## ASSESSMENT REPORT

### WOODLAWN WASTE BIOREACTOR PROJECT MP 10\_0012 MOD 1; DA 31-02-99 MOD 2

**Figure 3:** Detail of Evaporation Dam 3 (Source: Proponent).  
**Note.** Pipelines and location of dams are show for illustration purposes only

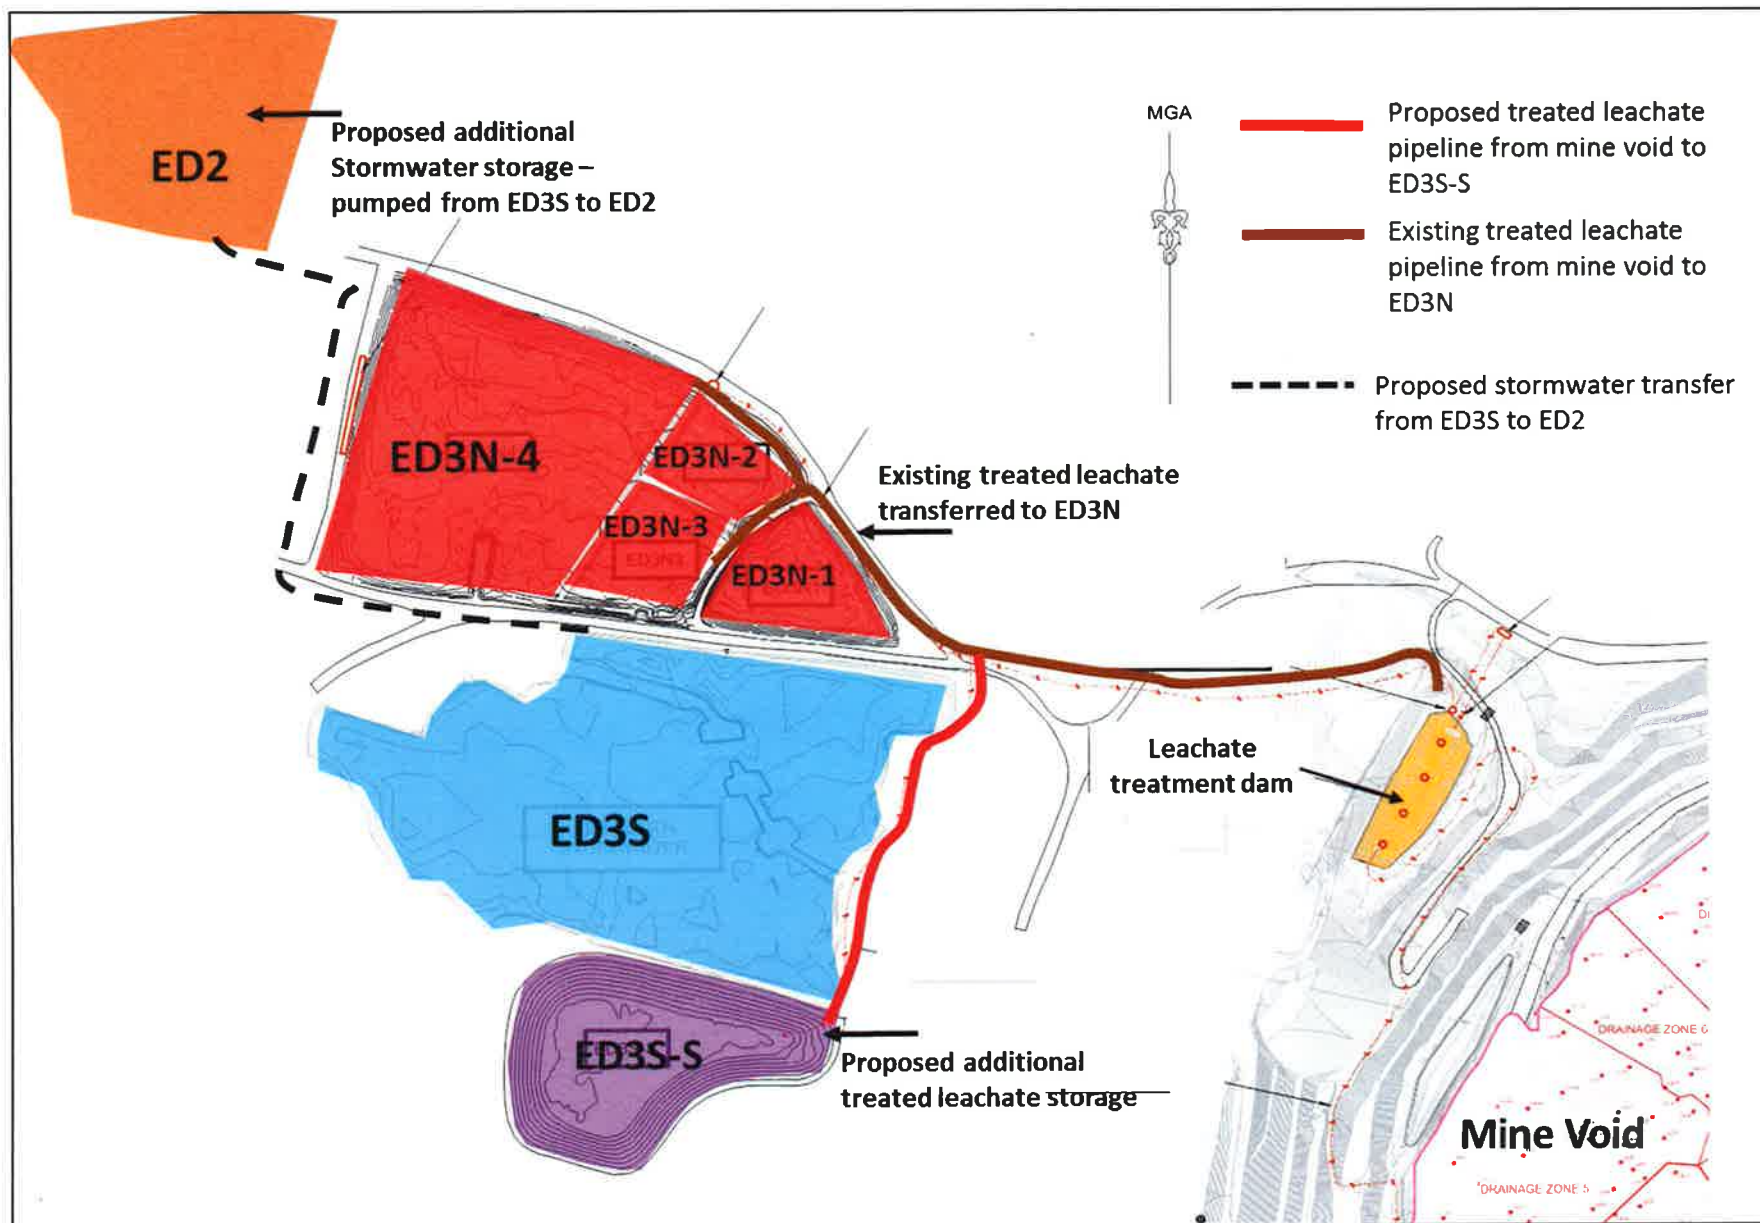
Following the Proponent's Response to Submissions, the Proponent advised that it would initially only use the southern portion off ED3S known as ED3S-S to store leachate. The remainder of ED3S would only be used to store leachate if in the event ED3S-S fills faster than expected and additional short-term leachate storage is required. **Figure 3** illustrates the locations of the key site features and proposed changes.

Proposed Aspect	Description
Evaporation Dam 2 (ED2) (shown in orange on Figure 3)	<ul style="list-style-type: none"> <li>ED2 currently does not receive any runoff from external sources. The dam stores rainfall and runoff generated only within its footprint.</li> <li>ED2 is proposed to be used to store and evaporate stormwater from the mine void which is currently being achieved in the southern half of ED3S.</li> </ul>
Southern half of Evaporation Dam 3 (ED3S, shown in blue and purple in Figure 3)	<ul style="list-style-type: none"> <li>ED3S currently receives stormwater that is pumped out from the mine void. This dam also has 2 lagoons separated by a break wall.</li> <li>It is proposed to store treated leachate from the bioreactor in ED3S-S, in addition to the ED3N lagoons.</li> <li>ED3S-S is currently empty, lined and ready for use as storage for treated leachate.</li> <li>It is proposed that water currently stored within ED3S would be transferred to ED2, and then it would be lined and used to store leachate, should ED3S-S be full.</li> <li>Approximately 10% of the storage area within the northern lagoon of ED3S is proposed to be used as a sump to facilitate stormwater transfer from the mine void to ED2.</li> </ul>

Above ground pipes	<ul style="list-style-type: none"> <li>A pump and pipe system is proposed to be installed to regulate and handle the leachate flow and stormwater transfer between the mine voids, ED3S, ED3S-S, ED3N and ED2.</li> </ul>

The Department has also recommended conditions requiring: ED3S-S to be lined prior to storing leachate (to minimise the risk of leakage); and the Proponent to undertake quarterly monitoring of the capacity of ED3S-S to ensure sufficient volume is available until the long-term management solution comes on line. If in the event ED3S-S fills more quickly, the Department is satisfied ED3S could potentially be used for additional leachate storage provided it was appropriately lined and the Proponent has approval for a long-term leachate management solution in place. The Department has recommended appropriate conditions accordingly.

Based on the Proponent's modelling, the Department is satisfied ED2 has sufficient capacity to store mine void stormwater. However, the Department notes the Proponent's assessment identifies seepage is likely to occur from ED2. To ensure the integrity of ED2 is sufficient, the Department has recommended conditions requiring ED2 to be lined to minimise the risks of leaking acid mine drainage.

- no leachate to be discharged into ED2;
- a surface water monitoring program to be prepared and implemented, to monitor the quality and quantity of water stored in ED2; and
- a management plan for ED2 to be prepared and included in the site's Landfill Environmental Management Plan.
